**STAFF RECOMMENDATION**  
**2529 Fairfax Avenue**  
**March 17, 2021**

**Application:** New Construction—Addition  
**District:** Hillsboro-West End Neighborhood Conservation Zoning Overlay  
**Council District:** 18  
**Base Zoning:** RS7.5  
**Map and Parcel Number:** 10411013600  
**Applicant:** Alan Dooley, Architect  
**Project Lead:** Sean Alexander, sean.alexander@nashville.gov

<p><b>Description of Project:</b> A proposal to construct a side addition to an historic house. The addition will replace an existing side addition, increasing the width of the house by ten feet (10'). The addition will be one story, with a roof form and pitch matching the existing roof.</p> <p><b>Recommendation Summary:</b> Staff recommends approval of the proposed addition with the following condition:</p> <ol style="list-style-type: none"><li>1. The masonry and window and door selections are approved prior to purchase and construction.</li></ol> <p>With these conditions, staff finds that the proposal will meet the design guidelines for new construction in the Hillsboro-West End Neighborhood Conservation Zoning Overlay.</p>	<p><b>Attachments</b></p> <ul style="list-style-type: none"><li><b>A:</b>

**NORTH ELEVATION**

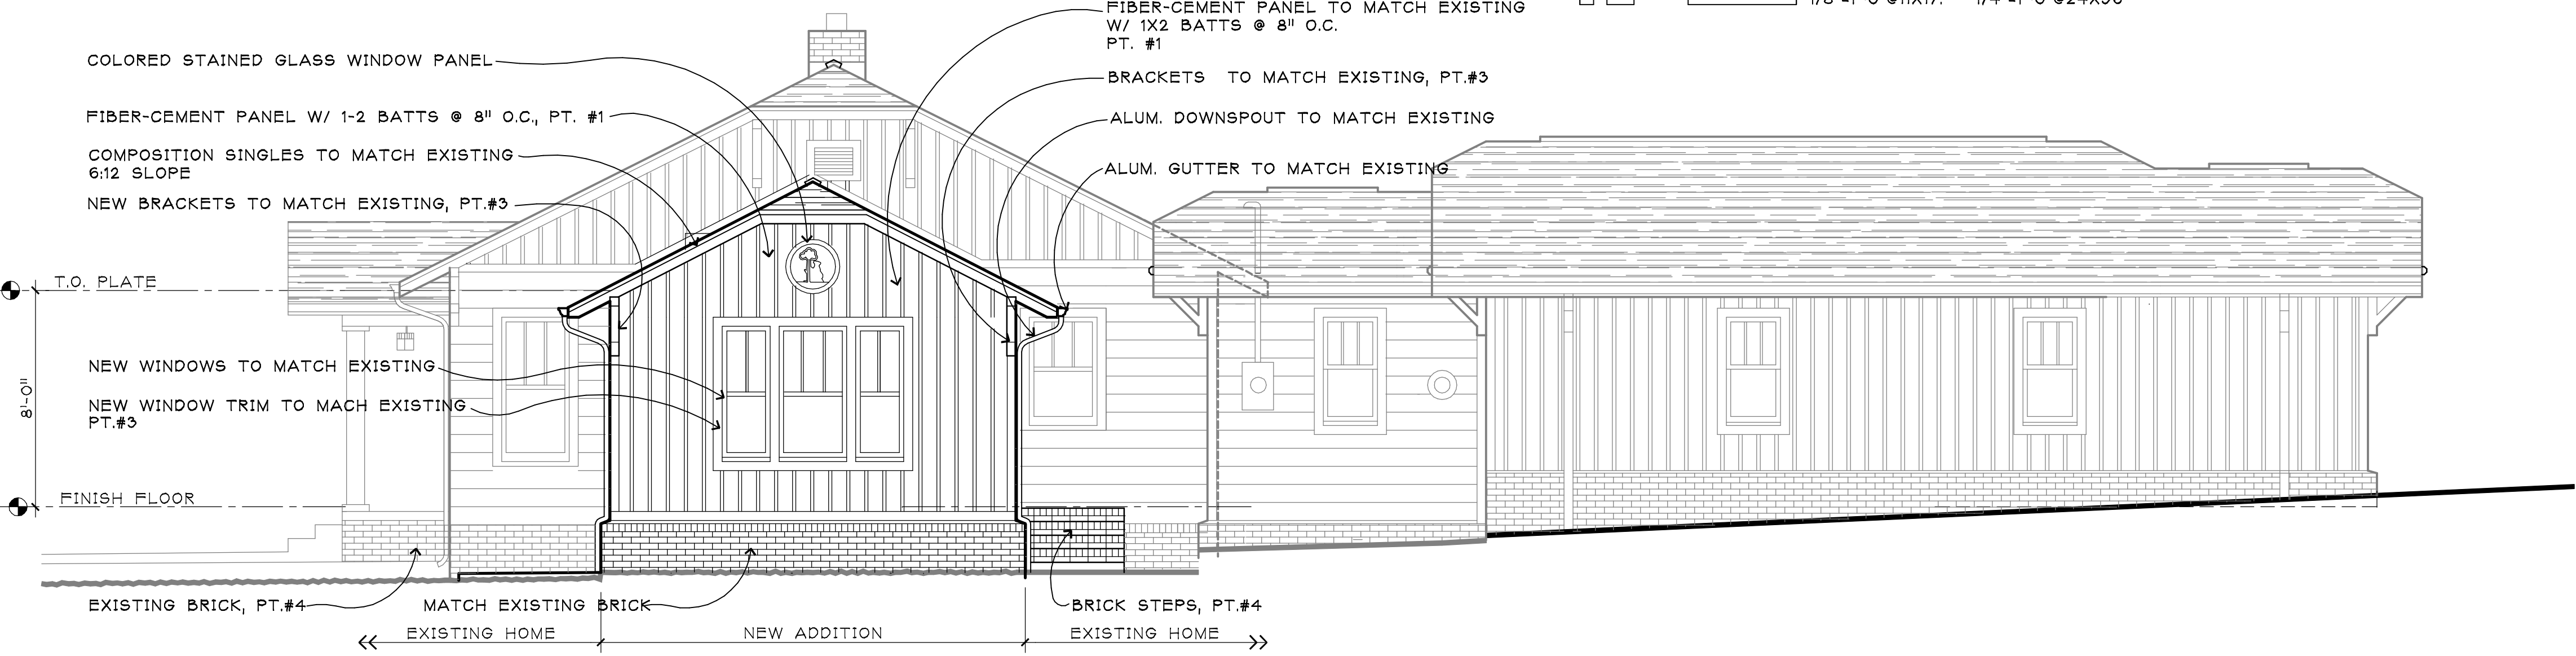
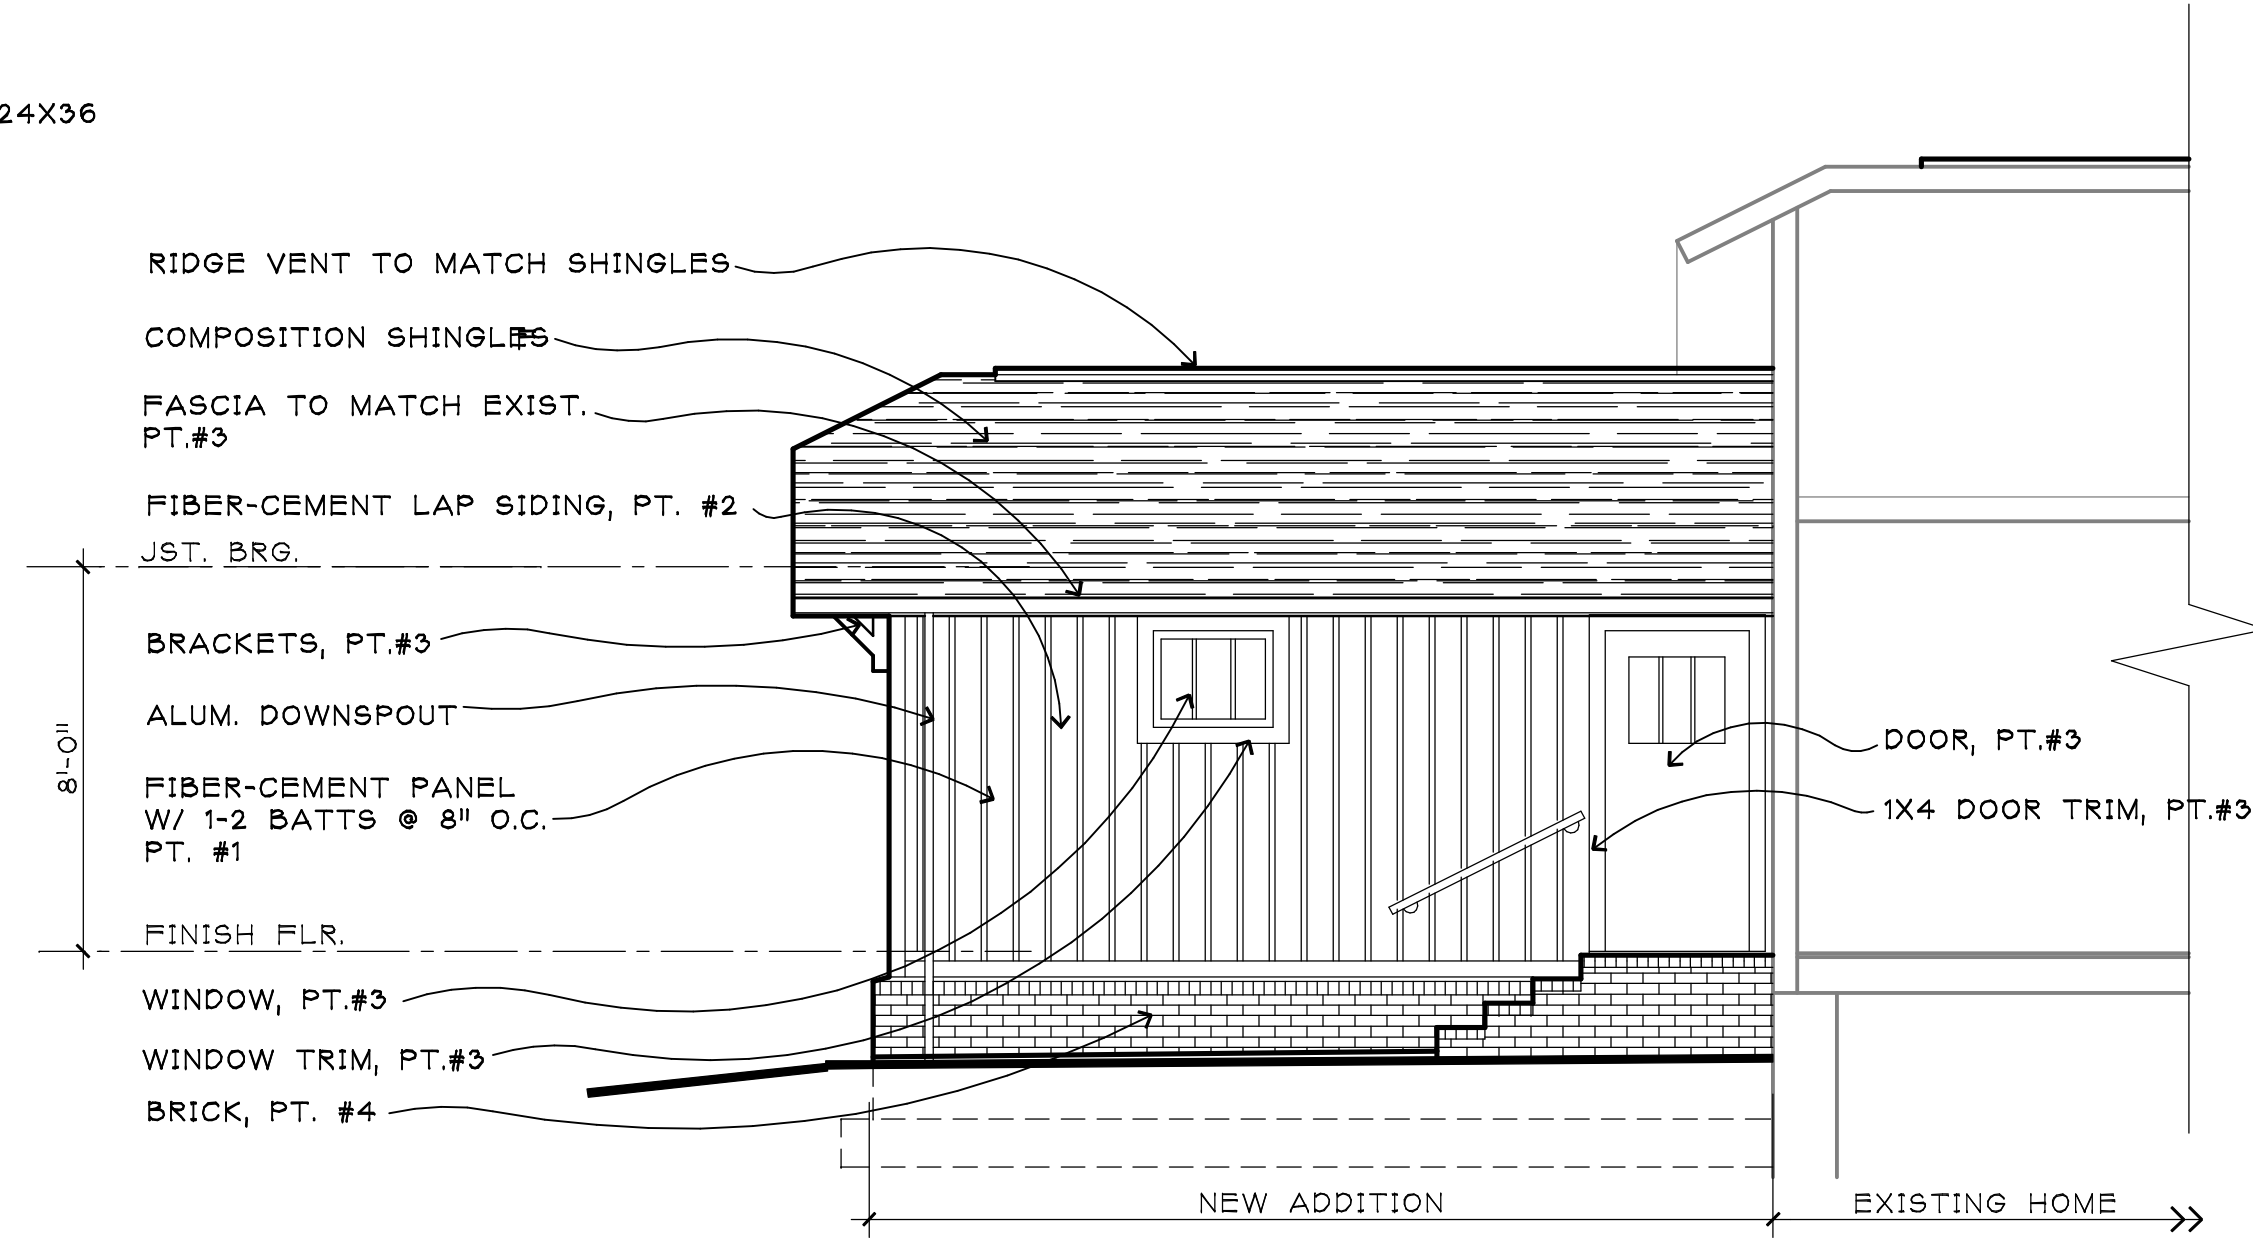
Roof form: The roof of the addition will be a side-oriented gable, matching the pitch and form of the historic house’s roof.

Proportion and Rhythm of Openings: The front façade of the addition will have five fixed door panels, with a muntin pattern matching the windows in the historic house. The right side wall of the addition will have a three-part window with double-hung windows matching the front window pattern on the historic house. Staff finds that the windows on the proposed addition are consistent with the pattern and proportions of windows on the historic house.

The proposal shows a stained-glass window in the upper portion of the side-gabled wall. This window will be round with a diameter of less than two feet (2’). Stained glass windows are not typical of historic houses of this age and type, but staff finds that because the size and location are such that the proposed window does not contrast so greatly as to detract from the historic character of the house.

Additional information on the masonry selections and the windows and doors is needed.

1. The masonry selection and window and door selections are approved prior to purchase and construction.
